A D D E N D U M #2

Project	Nelson H.S. Renovations	**Project No.**	2323
Location	4181 New Street, Burlington, Ontario	**Date of Issue**	2024 05 30
Owner	The Halton District School Board	**File**	2323/7.1.3

This Addendum forms part of the Contract Documents and amends the original Drawings and Specifications, dated 2024 05 13, as noted below.

1 E202 **GROUND FLOOR (EAST WING) MODIFICATION LAYOUT (PART 1/2)**
1:100

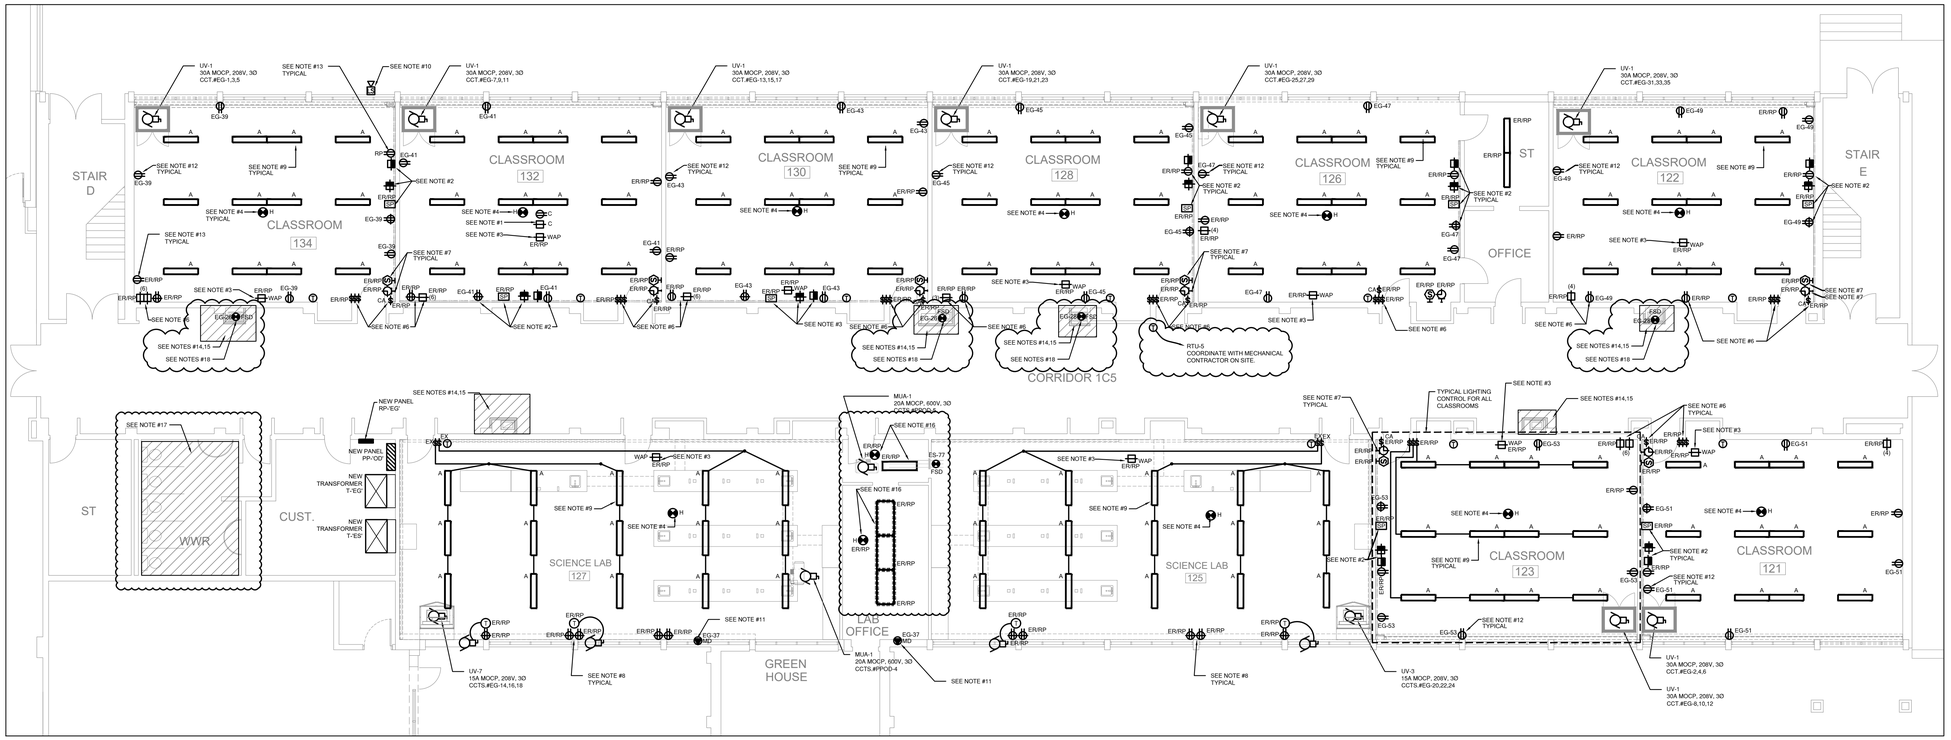
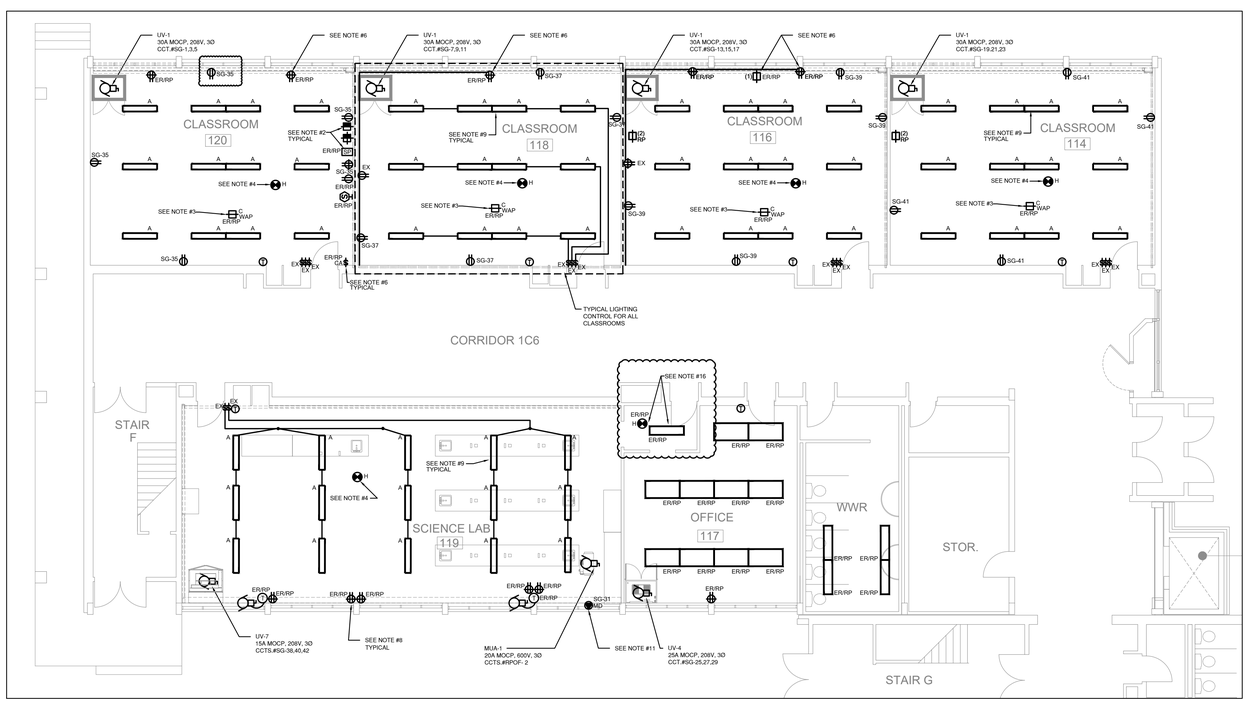
.1 Refer to Drawing E202 and include the changes indicated.
- Added note #17 and scope of work in the washroom,
- Clarified receptacle circuit in classroom 120.
- Added note #16 and associated work in Science Lab #119.
- temperature sensor rough-in added in the corridor.
- Added duct smoke detector for fire smoke damper and note #18 in corridor 1C5.

1 E203 GROUND FLOOR (SOUTH WEST WING) MODIFICATION LAYOUT (PART 1/2)
1:100

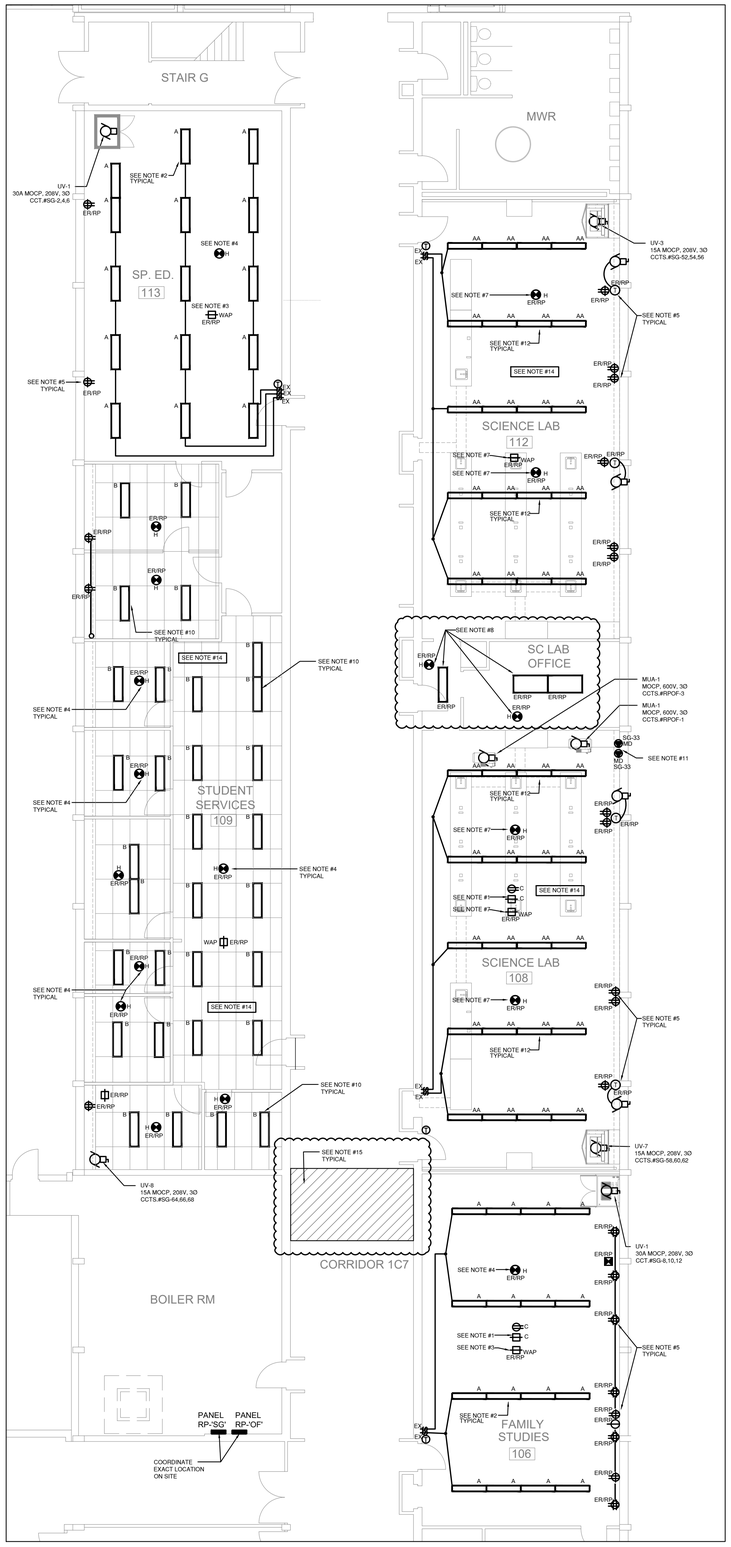
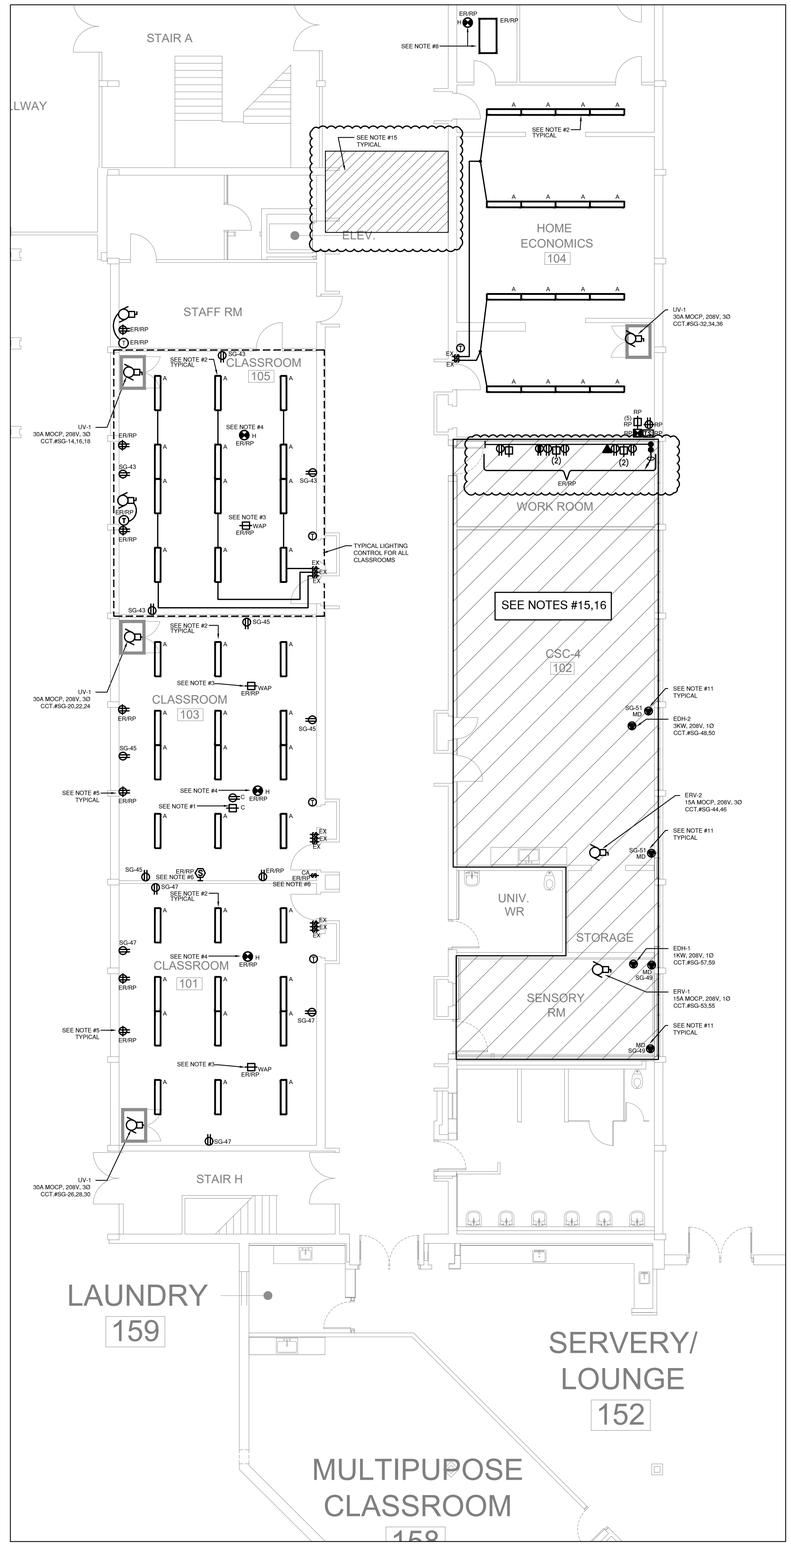
.1 Refer to Drawing E203 and include the changes indicated.
- Modified note #15, and indicated area of work in the corridor.
- Added additional power and communication service work in the workroom to suit mechanical and architectural demolition work.

1 / E300 **SECOND FLOOR (EAST WING) DEMOLITION LAYOUT (PART 1/2)**
1:100

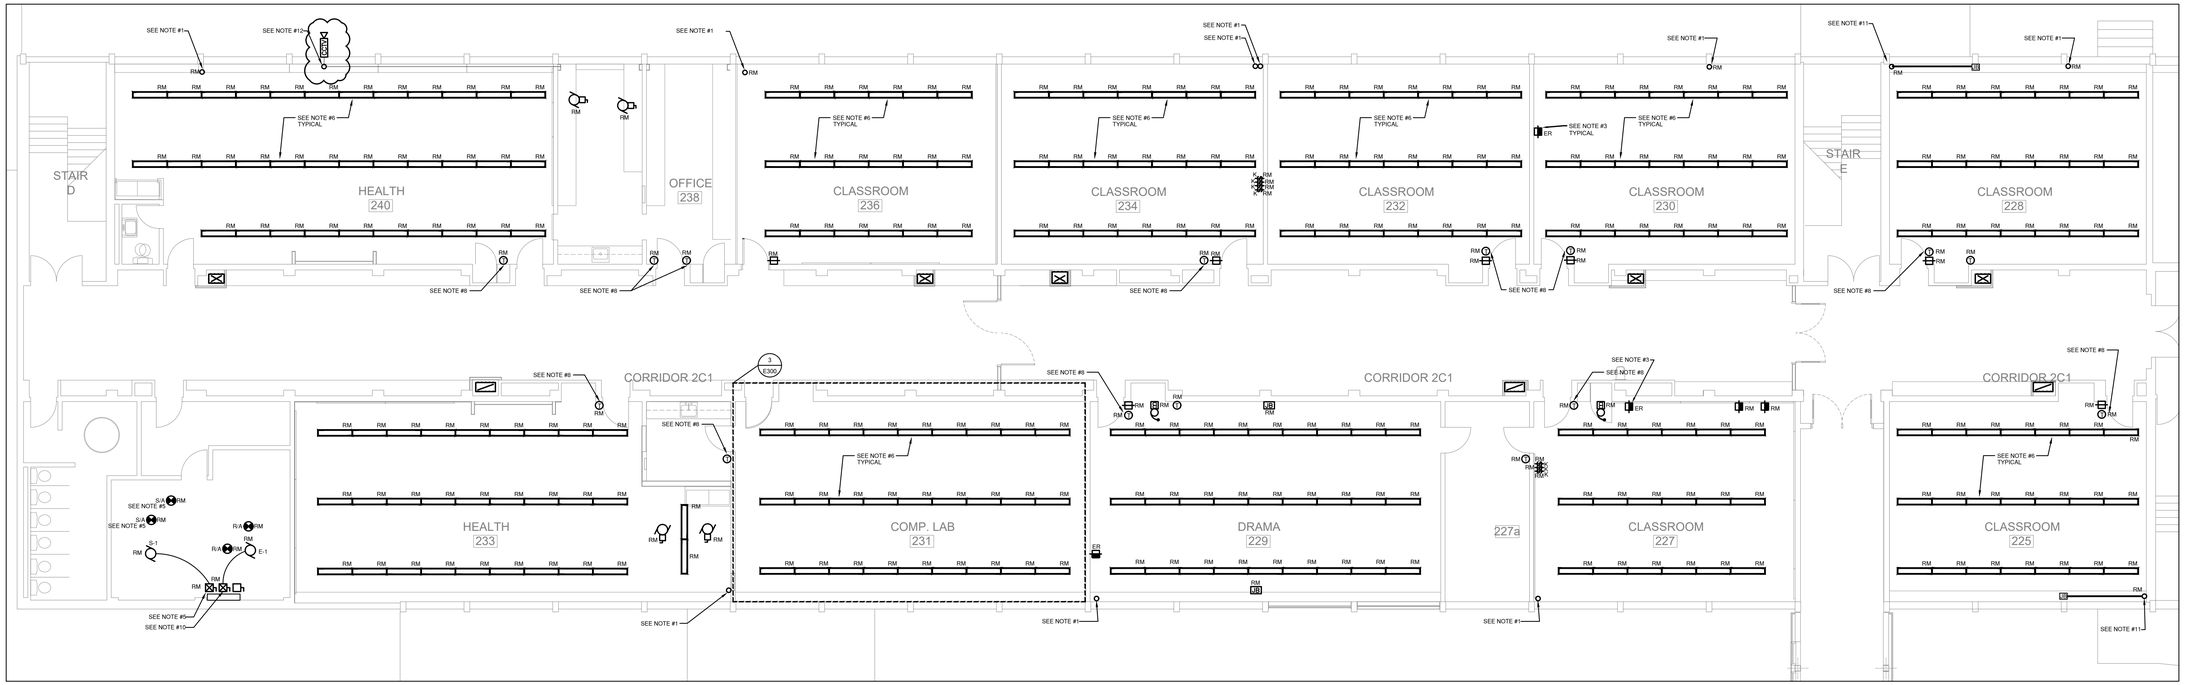
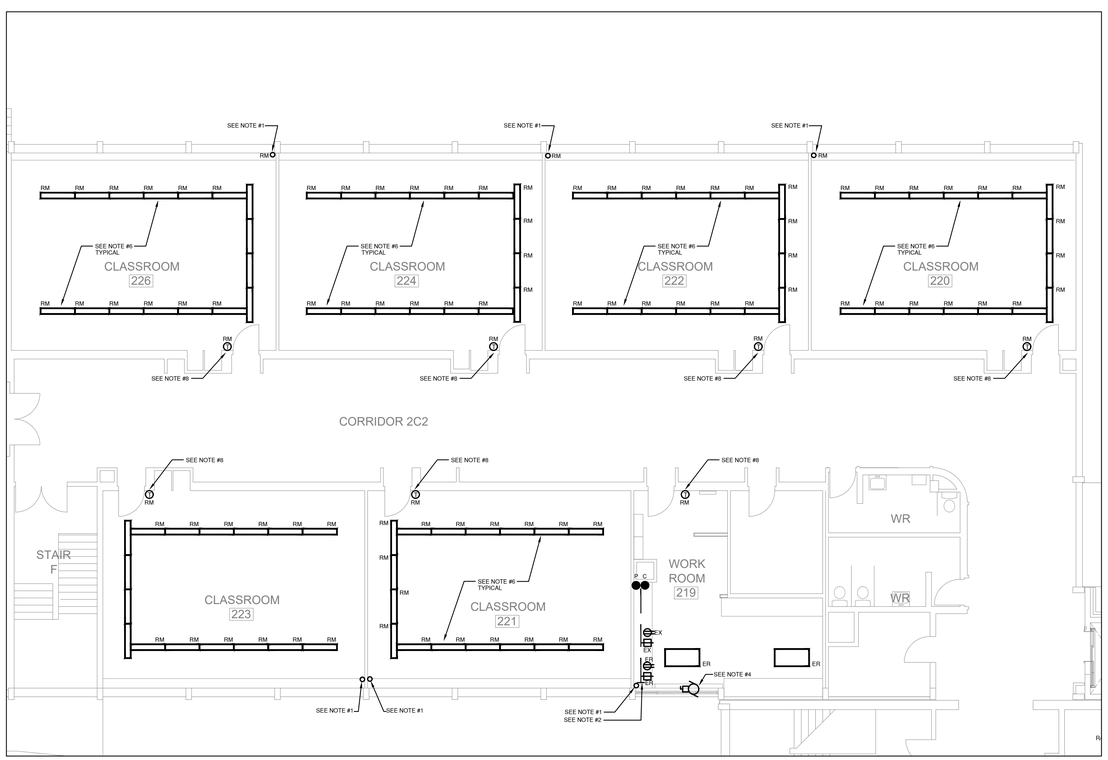
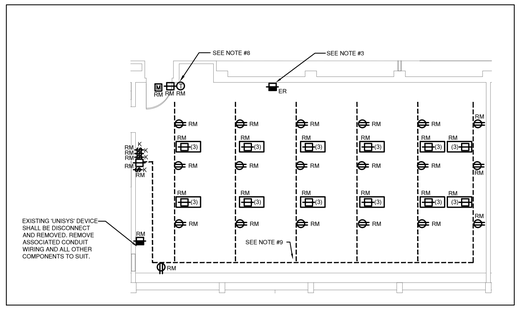
.1 Refer to Drawing E300 and include the changes indicated. Note #12 has been revised.
